Re: **Addendum to the Highway 407 Transitway Corridor Assessment Within the Ninth Line Lands Study Area (Amec Foster Wheeler, 2016), City of Mississauga**

This memorandum is provided as an Addendum to the "Highway 407 Transitway Corridor Assessment Within the Ninth Line Lands Study", completed by Amec Foster Wheeler (now Wood) for the City of Mississauga in October 2016. The need for this addendum has been largely driven by concerns raised by Conservation Halton (CH) with respect to the originally-proposed use of a Flood Protection Landform (FPL) to protect existing and future land north of Britannia Road, as well as concerns related to the need for a wider watercourse meander belt width and maintenance access north of Derry Road. The approaches to addressing CH concerns are summarized in the following subsections, which deal specifically with the Transitway segments to which they apply (namely Segment 3 for the FPL and Segment 5 for provision of additional meander belt width). The limits of the Transitway segments as defined under the 2016 Transitway Corridor Assessment Study are as defined and illustrated in Table 1.

Figure No. 6

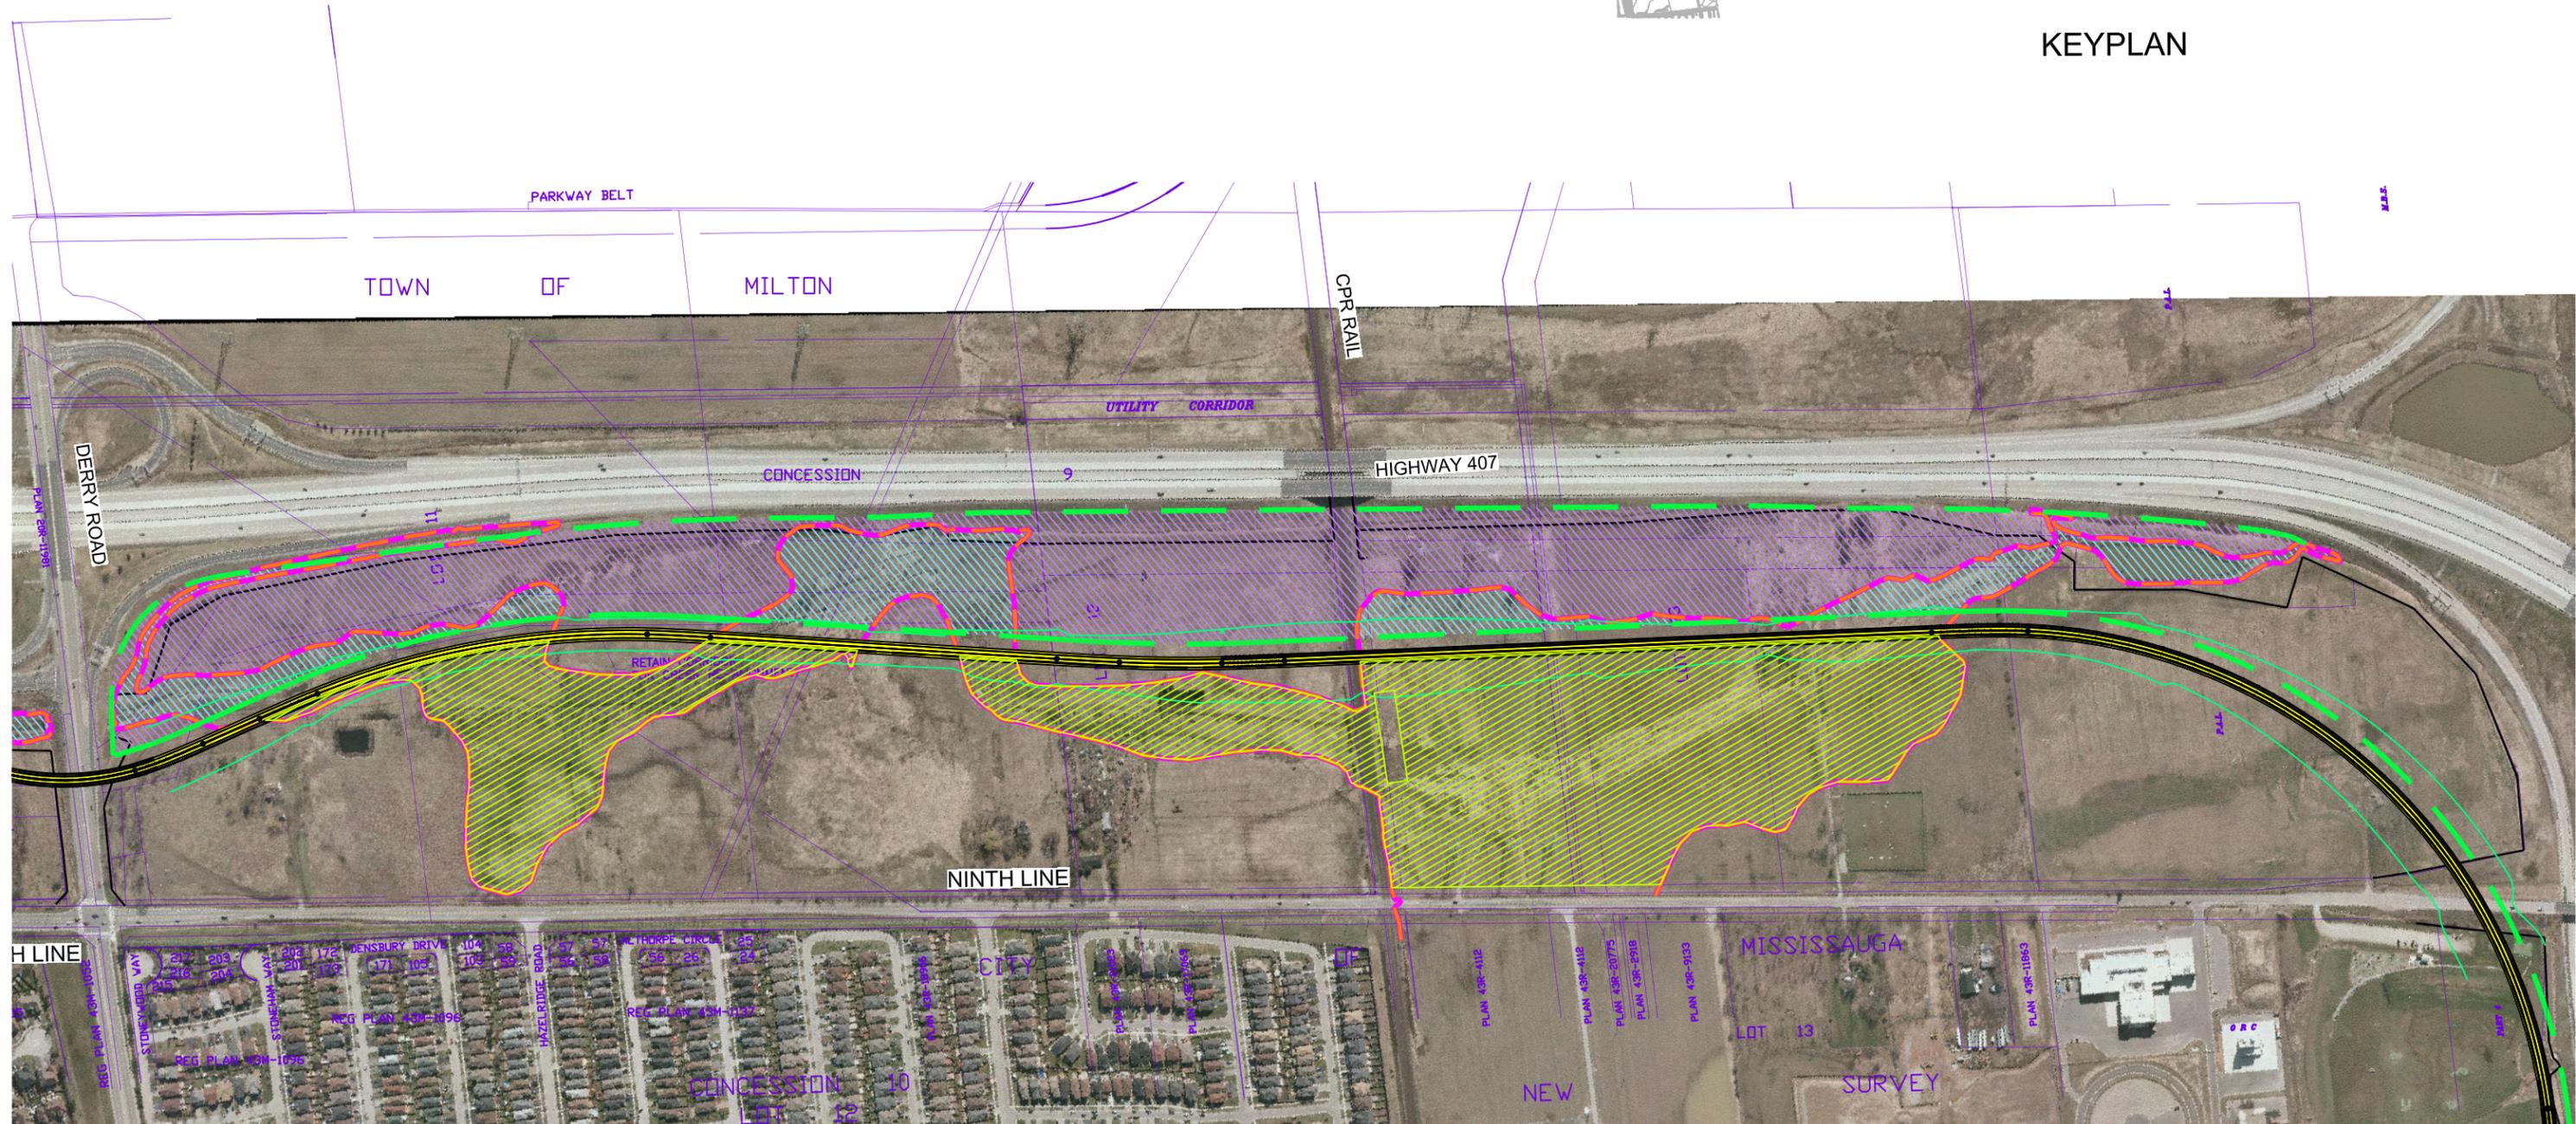
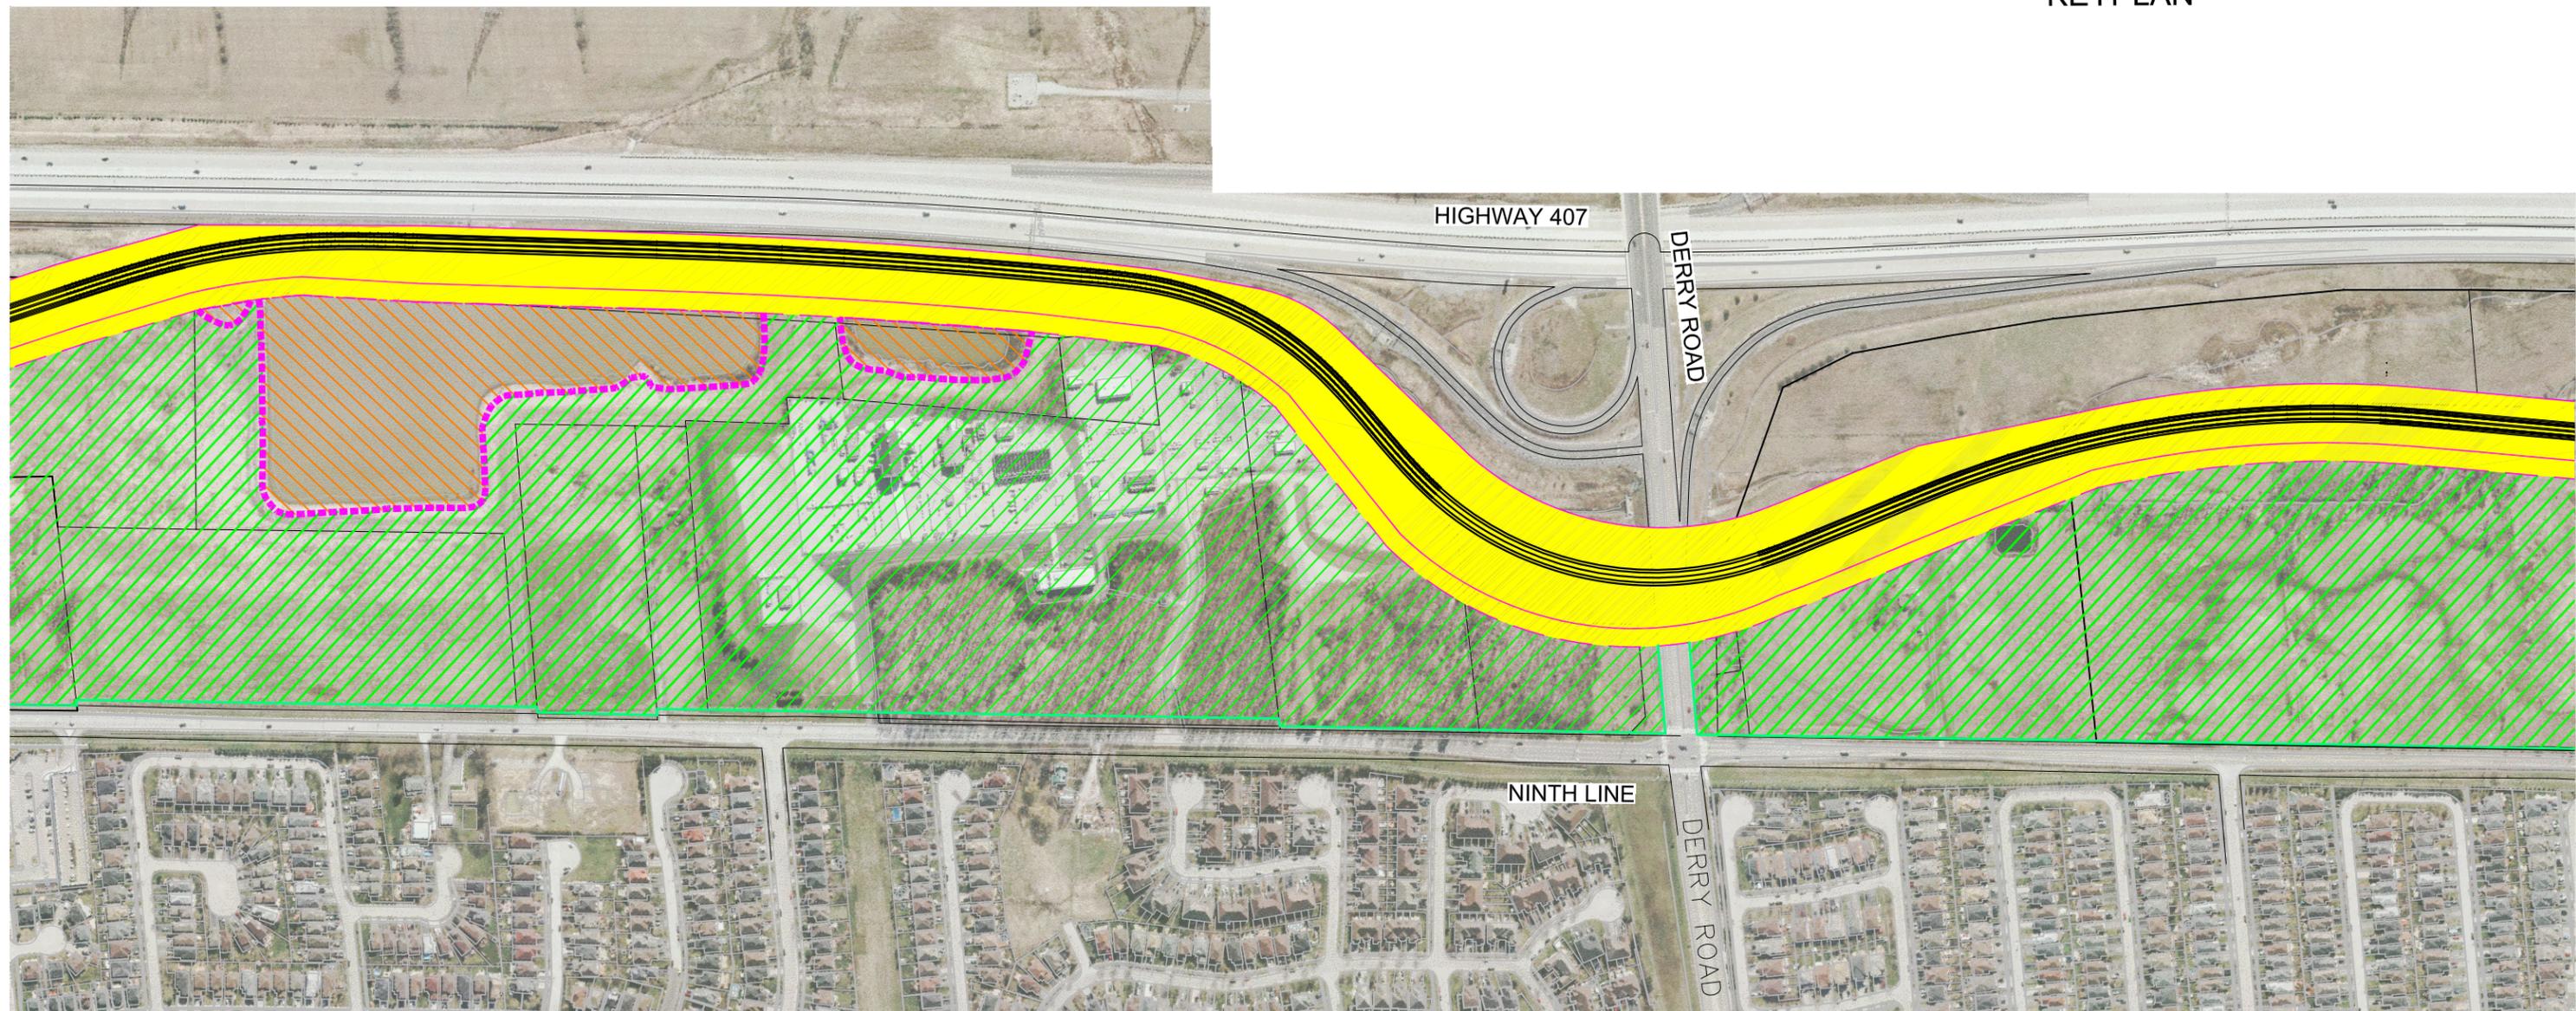
Changes to the Regional Storm Floodplain associated with the amended Transitway alignment are illustrated in attached Figure 6<sup>d</sup>, while changes to the developable land are illustrated in Figures 7, 8 and 9<sup>e</sup>.

Figure No. 7

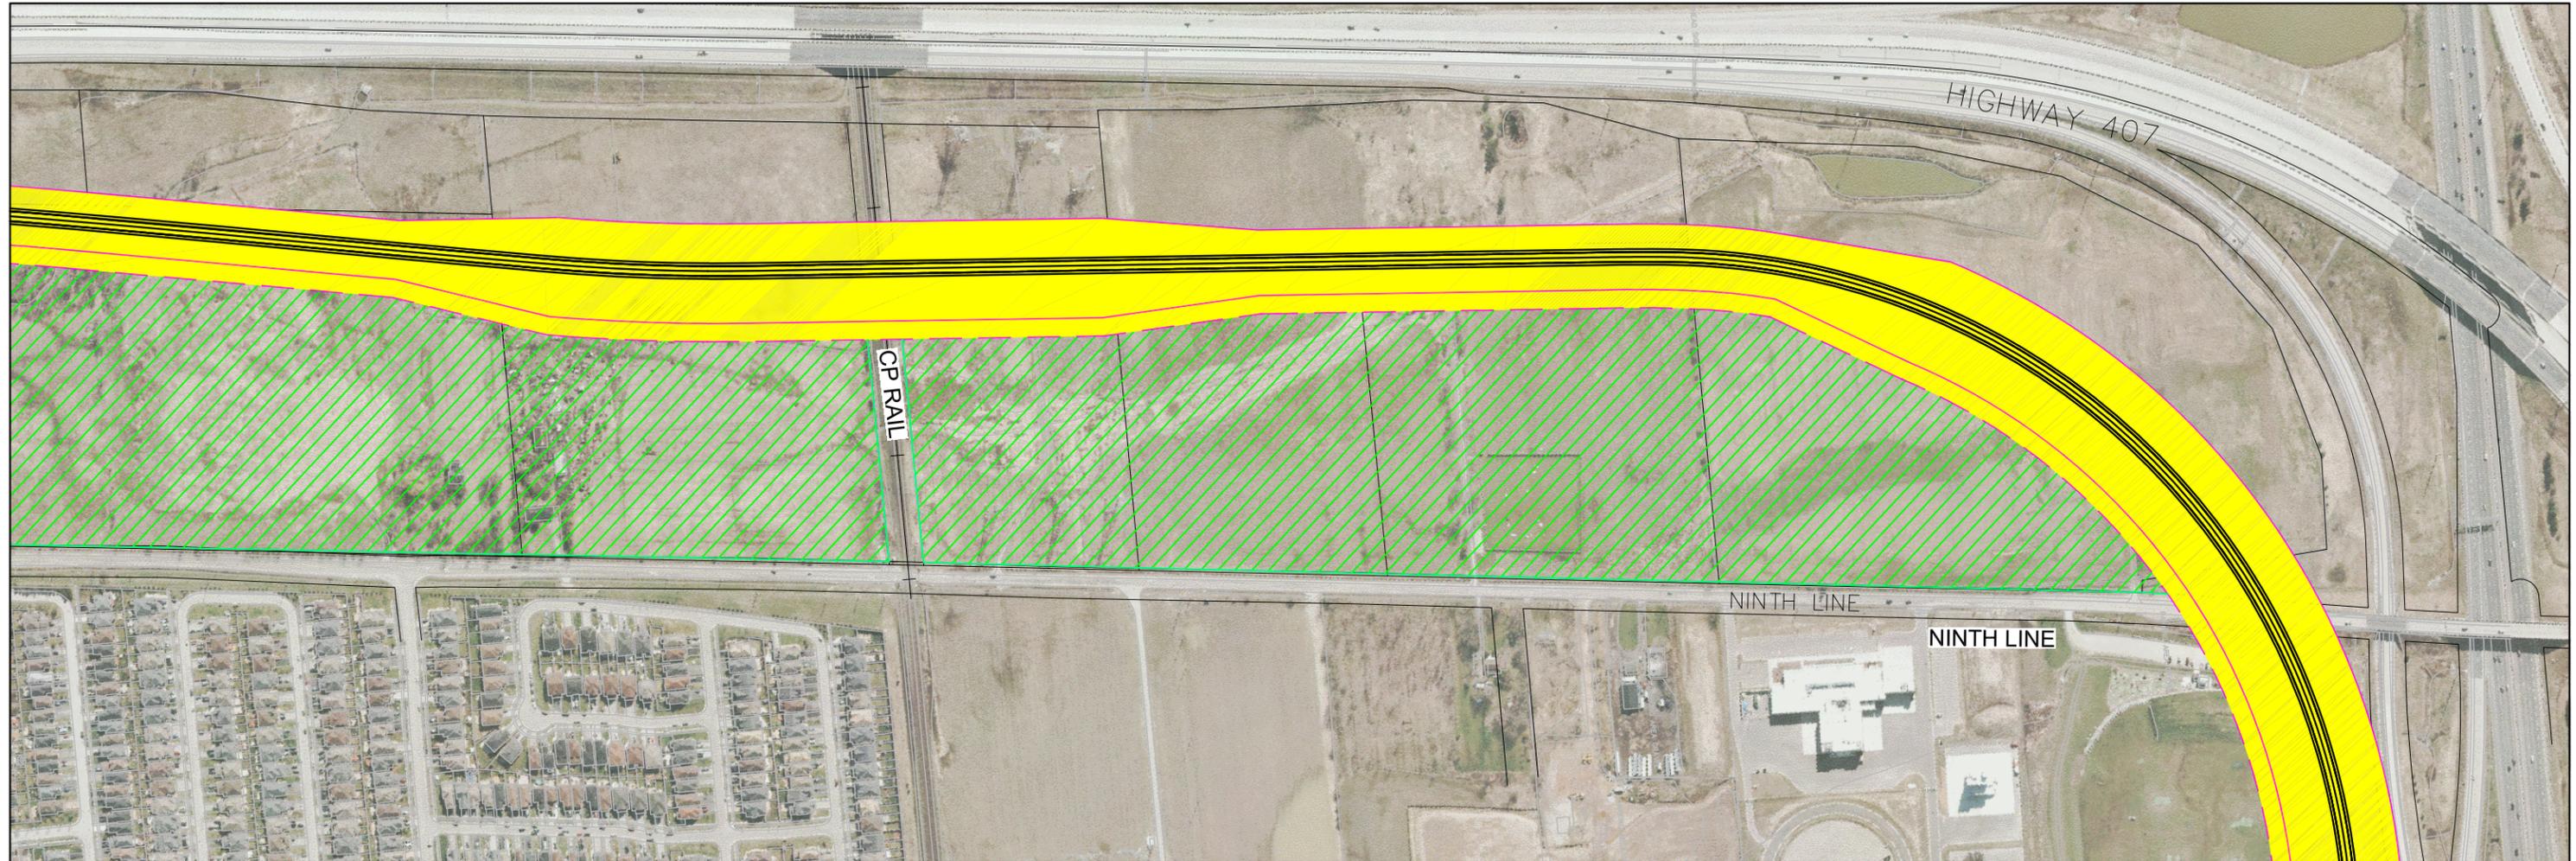
The proposed shift and realignment will impact the total area of developable land along the corridor within the Ninth Line Lands, as well as the proposed Park-and-Ride lot north of Derry Road. Utilizing the 2016 Transitway alignment, total developable lands bounded by Derry Road, the Transitway and Ninth Line were estimated at 45 ha (+/-) (including ~15 ha made available through refinement of the Regional Storm floodplain). With the revised alignment, developable lands within this area will be reduced by 6 ha to 39 ha (+/-). The conceptual Derry Road Park-and-Ride lot will also require minor adjustment to account for the additional impact to approximately 90 (+/-) parking spots, as a result of the Transitway realignment. Refinement of the required Park-and-Ride capacity and recommended layout is to be completed through the MTO Transitway EA.
